# ICC A117.1 Committee Action Report

## Proposal list to the 2017 A117.1 for the 2023 edition – 2-24-2022 through 1-19-2023 Chapter 6 to 11

**Figure 604.9.3(B)**  
**Wheelchair Toilet Compartment Doors**  
**Exception 3 – Alternate Wheelchair Compartment**

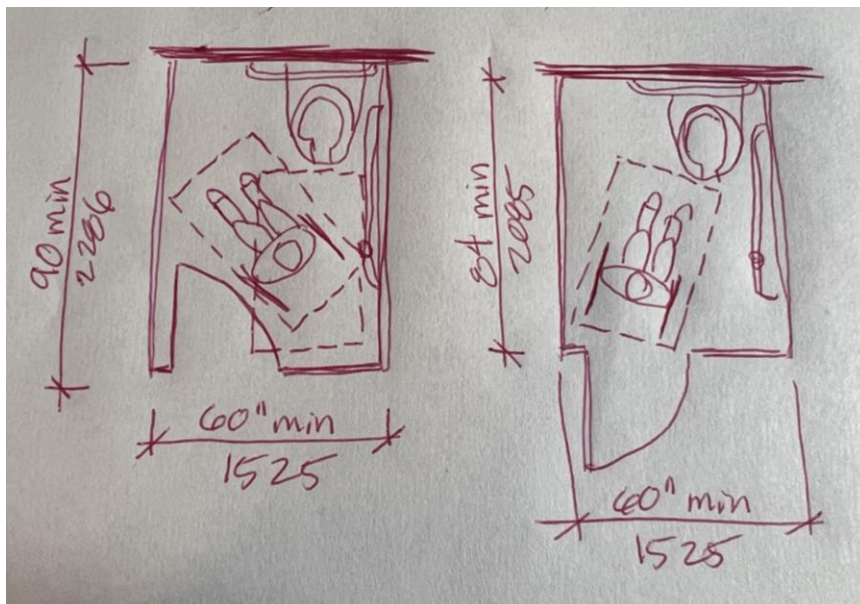
2. Within the wheelchair accessible toilet compartment, maneuvering clearances at the door shall not be required to comply with Section 404.
3. In an alternate wheelchair accessible toilet compartment, the door shall be permitted to swing into the stall compartment where the minimum depth of the stall is 90 inches (2286 mm) ~~a clear floor space complying with Section 305.3 is provided within the stall beyond the arc of the door swing.~~

This proposal ties and limits the third exception directly to the alternate compartment provisions of Section 604.9.2.3 and ensures that the door is located to allow a user to move straight into the stall. Without a limitation for the door to be located in the front wall (as was the original intent), Section 604.9.3.1 could be used to allow a side wall door. Again the original proponent and the committee were expecting the door for the “alternate” compartment to be located as shown in Figure 604.9.3(B) and to allow the user to move directly into the compartment and to allow a forward approach to the water closet.

By specifically referencing Section 604.9.2.3, the exception will clearly indicate when it is permitted to be used. This will ensure the exception is limited to the compartment configuration that was intended and that it is not used for other “alternate” (atypical) designs such as what is shown in Figure 604.9.3(A). Because a code user may select and use any of the exceptions, it is important that Exception 3 be limited to the specific alternate configuration which was intended and not be applied to other configurations which were not discussed and may not adequately address maneuvering within the compartment.

#### **604.9.5.2 Toe clearance at wheelchair accessible toilet compartments for children's use.**

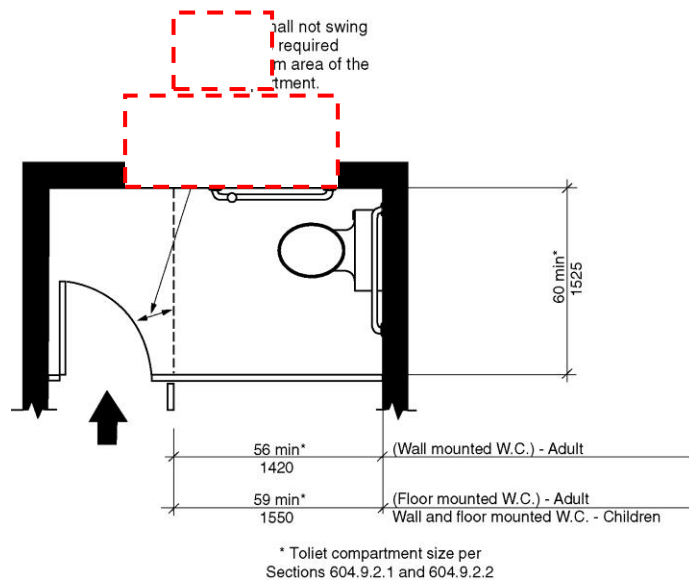
The front partition and at least one side partition of wheelchair accessible toilet compartments primarily for children's use shall provide a toe clearance of 12 inches (305 mm) minimum above the floor and extending 8 inches (205 mm) beyond the wheelchair accessible toilet compartment side face of the partition, exclusive of partition support members.

**FIGURE 607.3**  
**CLEARANCE FOR BATHTUBS CONTROLS**

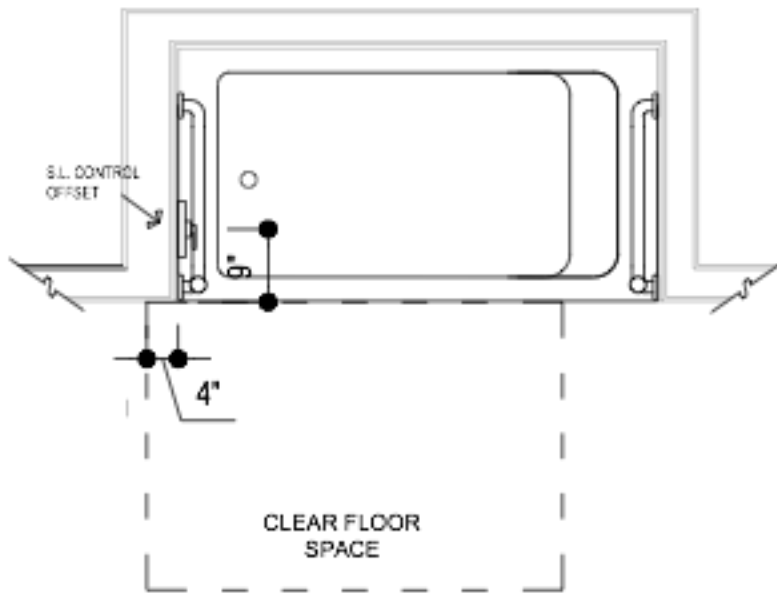
*Note: The wall in the Figures 607.2(A) and 607.2(B) would be jogged to indicate the additional 4 inch toe clearance in the new Figure 607.3. The committee will need to decide if Figures 607.2(A) and 607.2 (B) should be revised to show the control clearance with the transfer clearance or if the control clearance should be in a separate Figure 607.3. The figure submitted indicates the transfer clearance moving forward, not an addition 4 inch control clearance as the text indicates.*

**607.3 Control Clearance.** The clear floor space for toe clearance at the controls shall extend 4 inches (100 mm) minimum beyond the control end wall.

**FIGURE 607.3**  
**CLEARANCE FOR BATHTUBS CONTROLS**

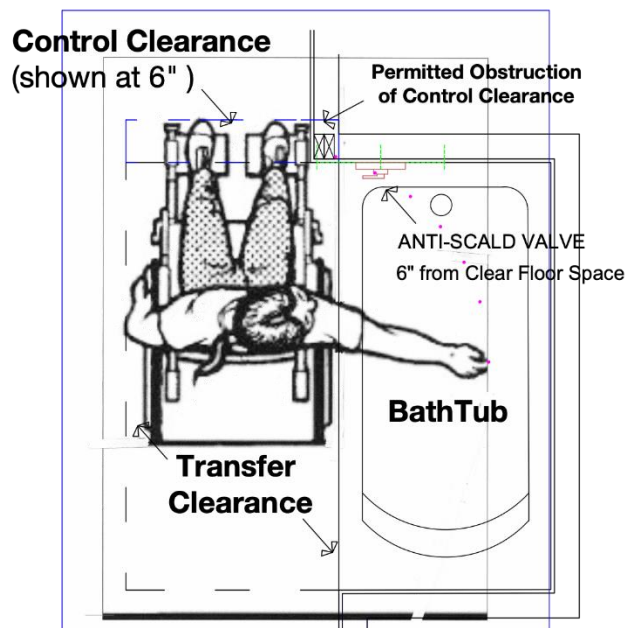
**607.3 Control Clearance.** The clear floor space for toe clearance complying with Section 306.2 at the controls shall extend 6 inches (152 mm) minimum beyond the control end wall. An obstruction by the control wall of 4 inches (102 mm) maximum shall be permitted.

*Note: The wall in the Figures 1103.11.2.5.1(A) and 1103.11.2.5.1(B) would be jogged to indicate the additional 6-inch control clearance in the new Figure 607.3*

Figure 607.4.2(A) Grab Bars for Bathtubs with Removable In-tub Seats – Elevation  
*Note – seat would have to move forward in graphic*

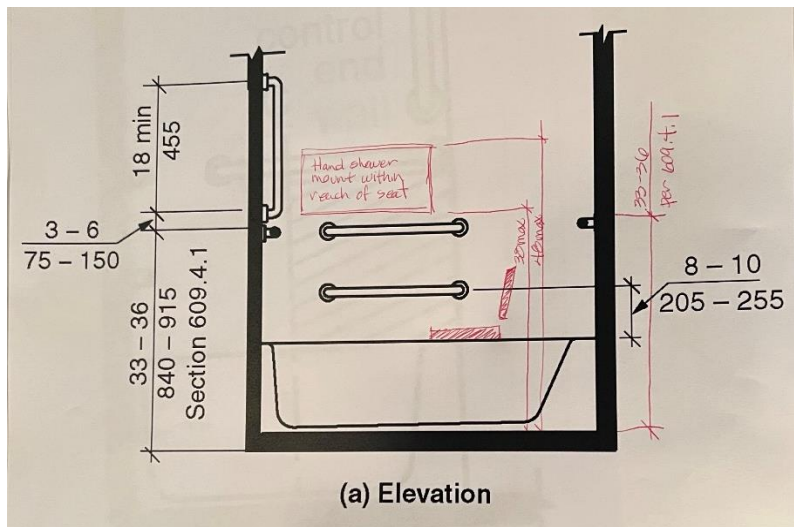
**607.4.2 Bathtubs with removable in-tub seats.** For bathtubs with removable in-tub seats, grab bars complying with Section 607.4.2 shall be provided.

**FIGURE 610.2(A) 610.2.1  
BATHTUB SEATS  
REMOVABLE IN-TUB SEATS**

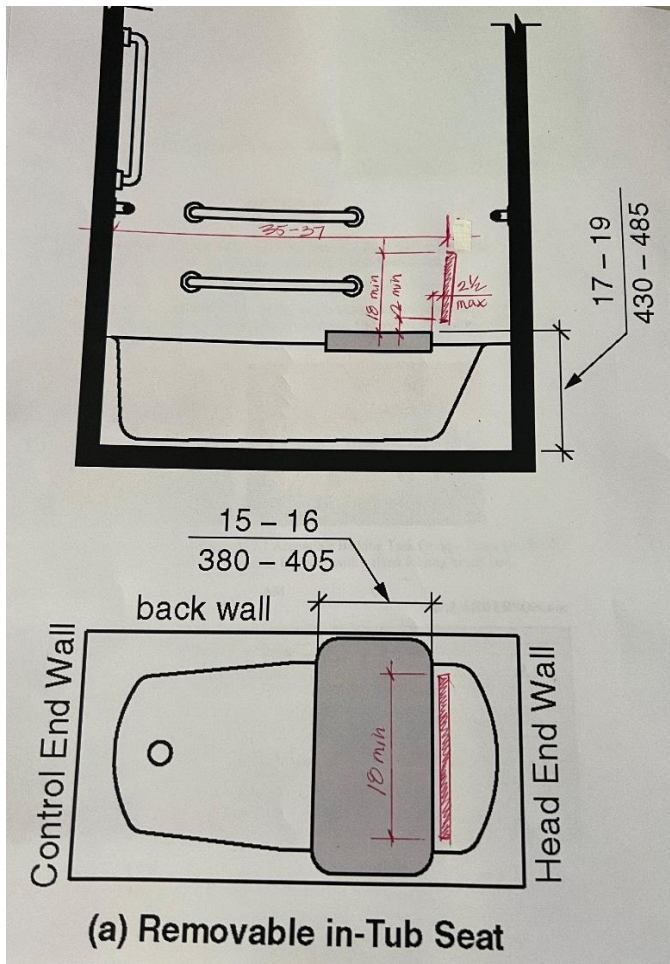
**610.2.1 Removable in-tub seats.** Removable in-tub seats shall be 15 inches (380 mm) minimum and 16 inches (405 mm) maximum in depth. The seat shall provide back support with the top edge of the back support 18 inches (455 mm) minimum above the seat surface. Removable in-tub seats shall be capable of secure placement with the rear edge of the seat surface positioned 36 inches (914 mm) maximum from the control wall.

**FIGURE 610.2(B) 610.2.2  
BATH TUB SEATS**

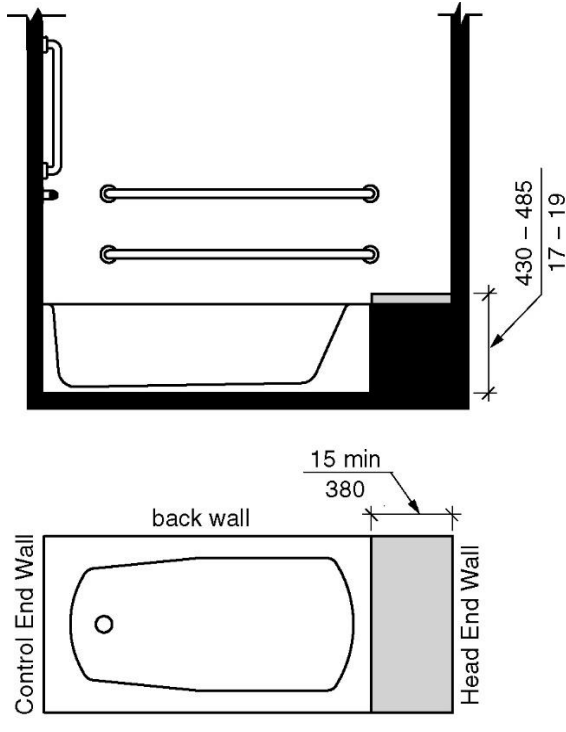
**610.2.2 Bathtubs with transfer platforms.** ~~Permanent seats~~ Transfer platforms shall be 15 inches (380 mm) minimum in depth and shall extend from the back wall to or beyond the outer edge of the bathtub. ~~Permanent seats~~ Transfer platforms shall be positioned at the head end of the bathtub.

**FIGURE 607.4.3(A)**

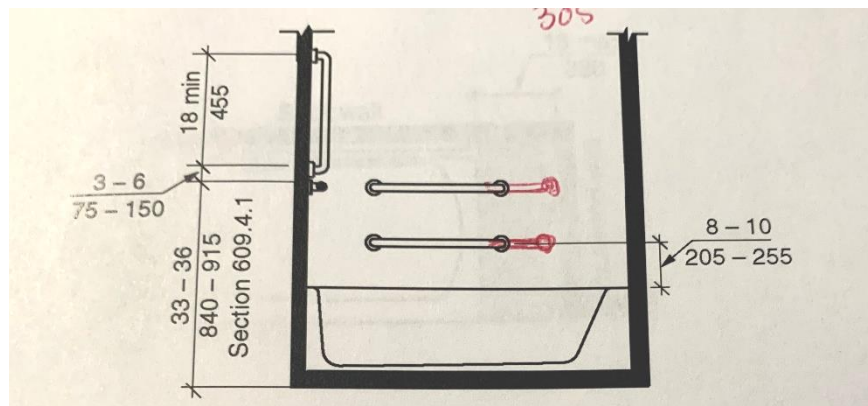
**607.4.3.2.2 Vertical grab bar.** A vertical grab bar 18 inches (455 mm) minimum in length shall be provided on the control end wall 3 inches (75 mm) minimum and 6 inches (150 mm) maximum above the horizontal grab bar, and 4 inches (100 mm) maximum inward from the front edge of the bathtub.

**FIGURE 607.4.3(A)**  
**GRAB BARS FOR BATHTUBS WITH FOLDING IN-TUB SEATS – ELEVATION**

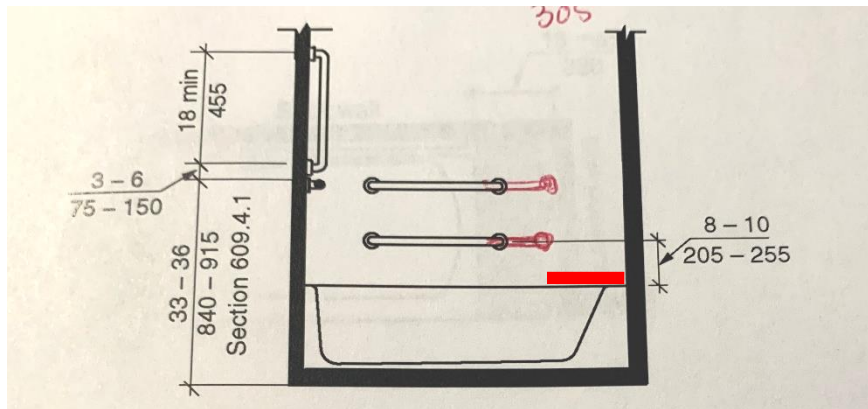
**607.4.3.2.2 Vertical grab bar.** A vertical grab bar 18 inches (455 mm) minimum in length shall be provided on the control end wall 3 inches (75 mm) minimum and 6 inches (150 mm) maximum above the horizontal grab bar, and 4 inches (100 mm) maximum inward from the front edge of the bathtub.

**FIGURE 607.6.2**  
**LOCATION OF MOUNT FOR BATHTUB WITH FOLDING SEAT**

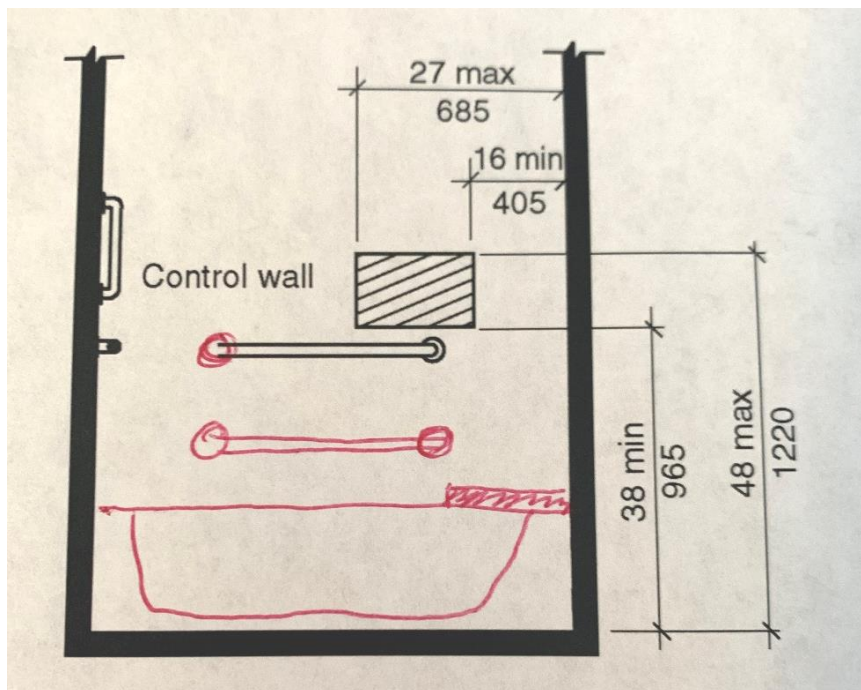
Exception: The mount to hold the hand shower shall be permitted to be located on a vertical bar provided that the mount is adjustable in height and can be located within the area specified for the fixed mount.

**FIGURE 610.2.3**  
**BATHTUB SEATS**  
**FOLDING IN-TUB SEAT PROVIDED AT HEAD END OF TUB**

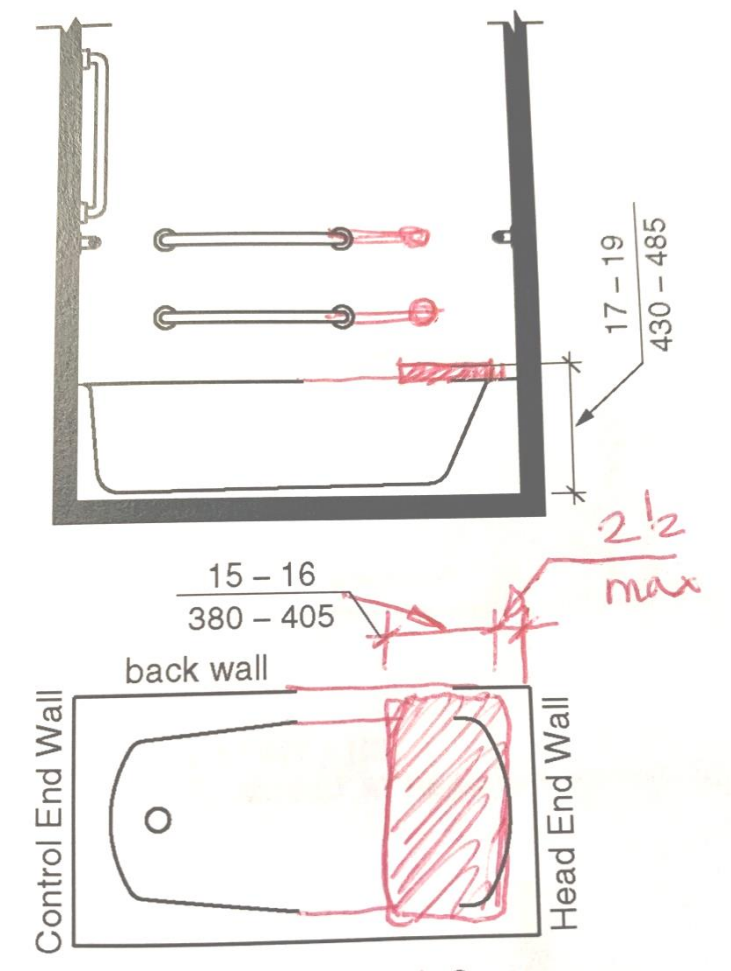
**610.2.3 Folding in-tub seats.** Folding in-tub seats shall be mounted on the head wall. The rear edge of a seat shall be 2-1/2 inches (64 mm) maximum and the seat shall be 15 inches (380 mm) minimum and 16 inches (405 mm) maximum in depth. The side edge of the seat shall be 1-1/2 inches (38 mm) maximum from the back wall.

**FIGURE 607.5.1**  
**LOCATION OF BATHTUB CONTROLS ON BACK WALLS**

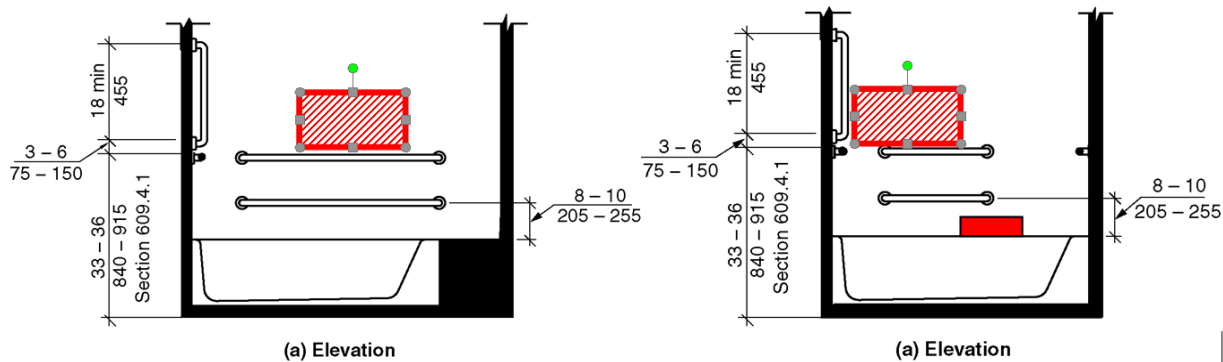
*Note: Add two new figures with dimensions to match text for rear wall controls.*

**FIGURE 607.5.1**  
**LOCATION OF BATHTUB CONTROLS DIVERTERS AND MOUNTS ON BACK WALLS**

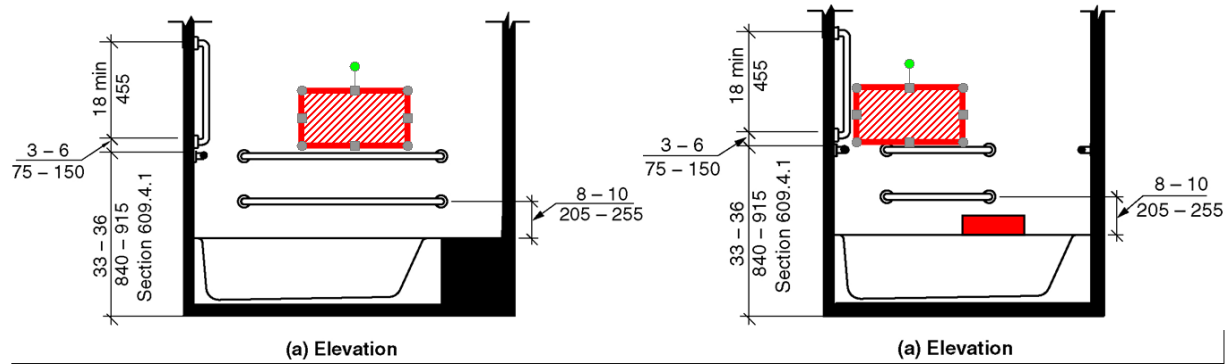
*Note: Add two new figures with dimensions to match text for rear wall controls.*

**FIGURE 608.4.3(C) ALTERNATE ROLL-IN-TYPE SHOWER HAND SHOWER MOUNT LOCATION - END WALL – ELEVATION**

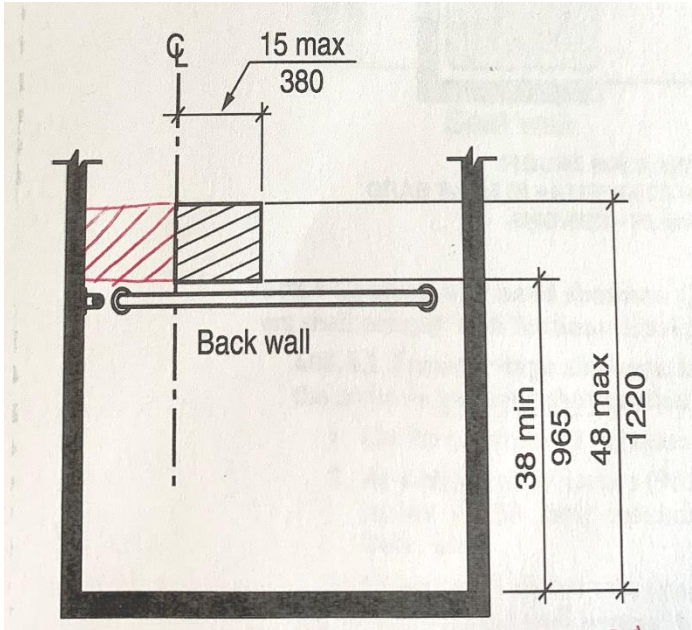
**Exception:** The mount to hold the hand shower shall be permitted to be located on a vertical bar provided that the mount is adjustable in height and can be located within the area specified for the fixed mount.

**FIGURE 607.5(B)**  
**EXCEPTION-LOCATION OF DIVERTER FOR BATHTUB WITH FIXED FOLDING**  
**IN-TUB SEAT**

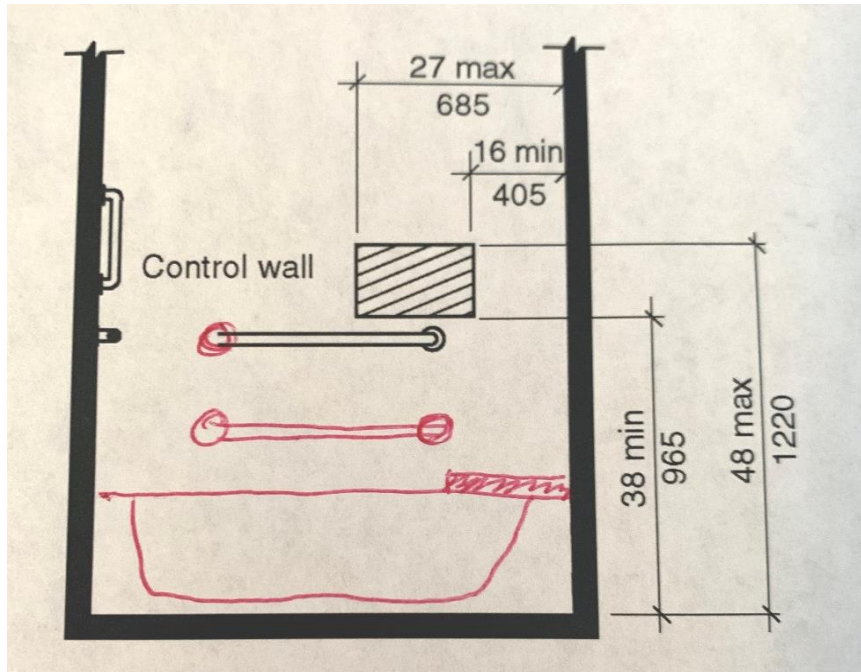
### 607.5, 607.6, Figure 607.5(B)(New)

**FIGURE 608.4.3**  
**STANDARD ROLL-IN-TYPE SHOWER WITH NO SEAT**  
**CONTROLS AND HAND SHOWER LOCATION**

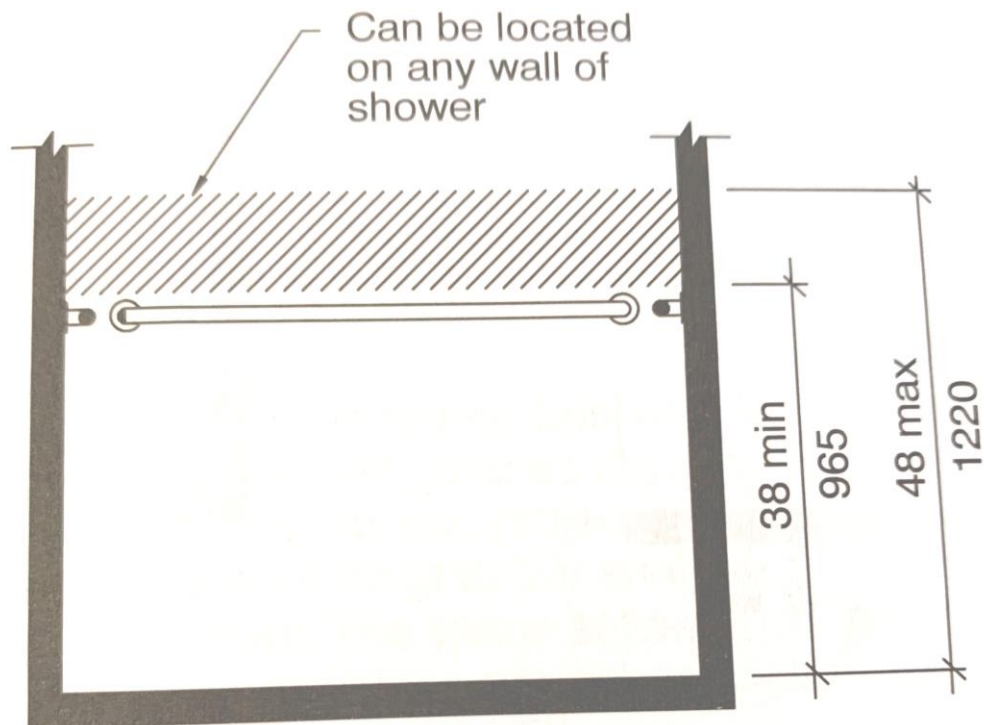
1. On the back wall or side walls.
2. At a height of 38 inches (965 mm) minimum and 48 inches (1220 mm) maximum above the shower floor.
